IG-ASEP-03-06

TF-QRTV on June-sessions

Discussion on clarification needed of conditions
for UN-R 138.02

JAPAN AUTOMOBILE STANDARDS INTERNATIONALIZATION CENTER

Fig. Reverse condition

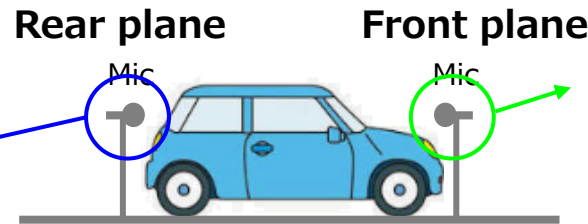
shall not exceed 75dB(A)
"R" range standstill
"R" range driving

Regarding when reversing (e.g., position "R") the maximum sound pressure requirement at the front plane of the vehicle, the current description is not coherent with TF-QRTV which has defined the limit value of 75dB(A) for both stand still and reverse driving. It may cause mis-understanding during type approval.

≠ Original intent
shall not exceed 75dB(A)
"R" range standstill
"R" range driving

During measurement in reverse the maximum level requirement **in the front line at the front plane** of the vehicle for forward driving ~~has to~~ **shall** be fulfilled in addition. **The maximum level requirement at the front plane of the vehicle at standstill condition in reverse shall be equal to the maximum level requirement in motion.**

Regarding when reversing (e.g., position "R") the maximum sound pressure requirement at the front plane of the vehicle, the current description is not coherent with TF-QRTV which has defined the limit value of 75dB(A) for both stand still and reverse driving. A text has been added to reflect the original intent and clarify the limit value agreed by TF-QRTV.
